August 19, 2014
BOARD OF COUNTY COMMISSIONERS
ORANGE COUNTY, FLORIDA

ADDENDUM NO. 7
IFB NO. Y14-748
ORANGE COUNTY EASTERN WATER RECLAMATION FACILITY
PHASE V AND CENTRIFUGE DEWATERING IMPROVEMENTS

FLOOR PLAN
SCALE: 1/4" = 1'-0"

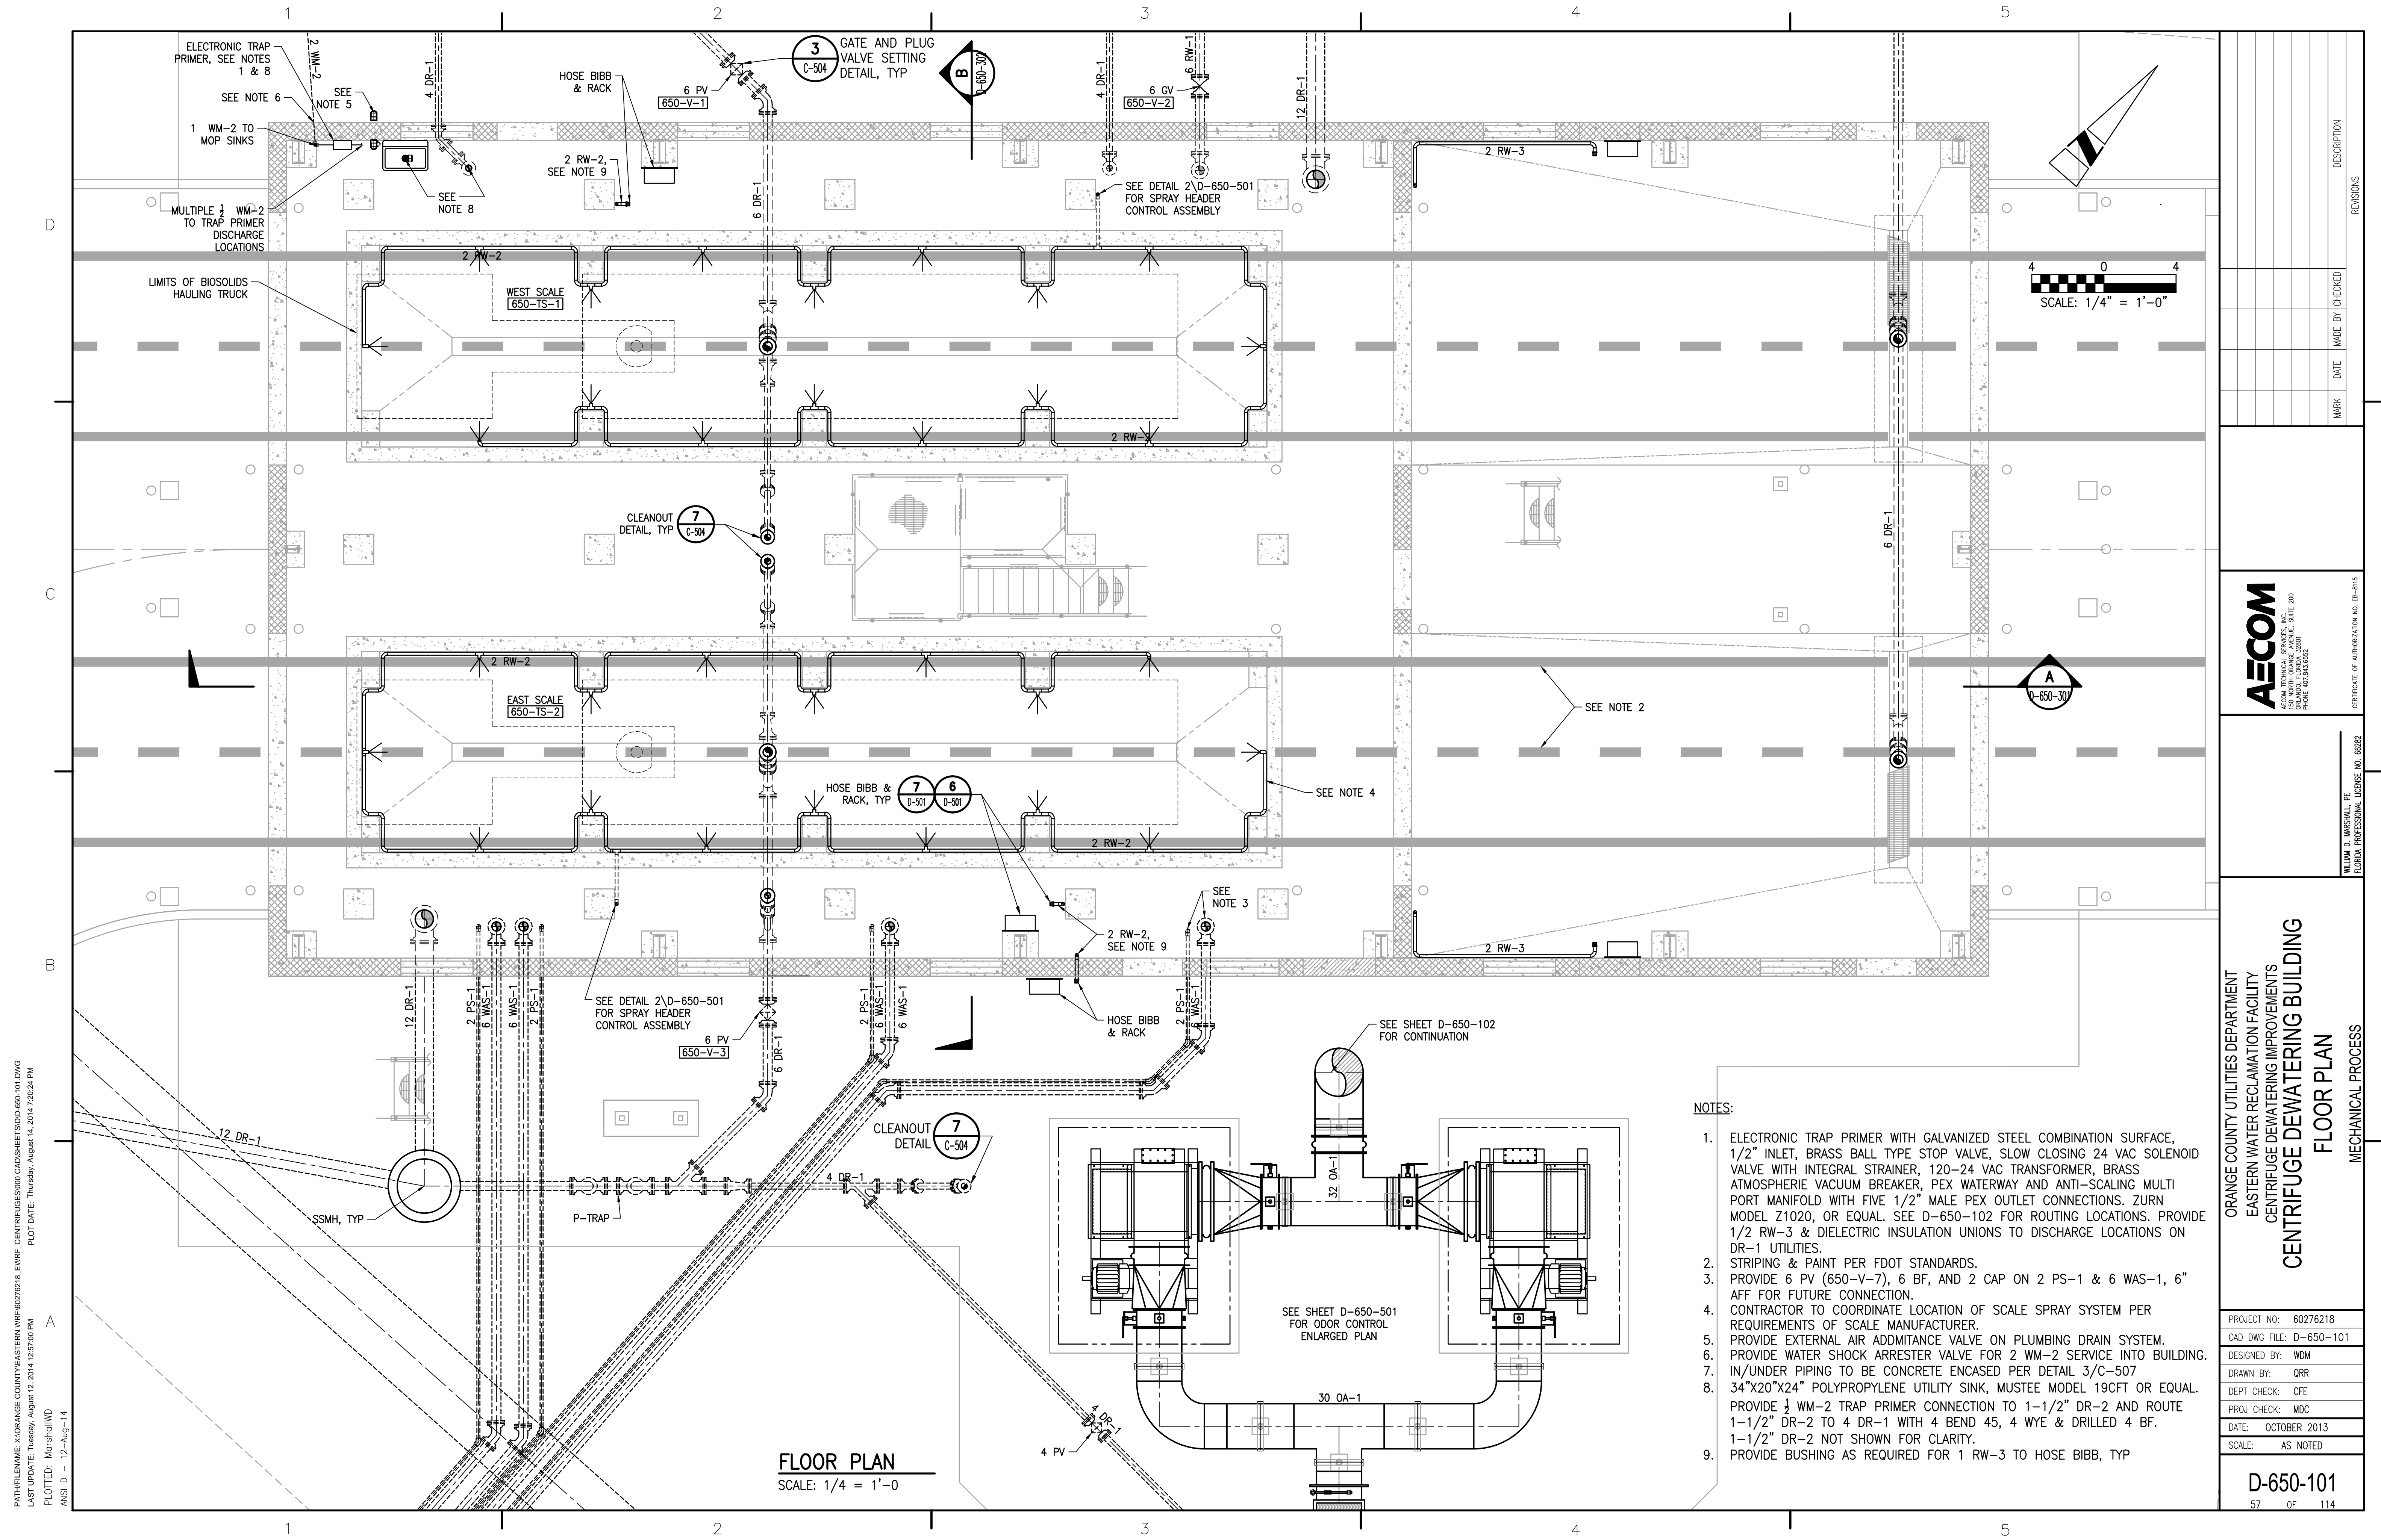
21. Bid Package B, Drawing D-650-101. The 4" DR-1 line going from the reducing wye to the carbon absorber shows a 6" Plug Valve in the line. Please clarify if this is to be a 4" plug valve.

The valve is to be a 4 PV please reference the revised Drawing D-650-101 (Attachment).
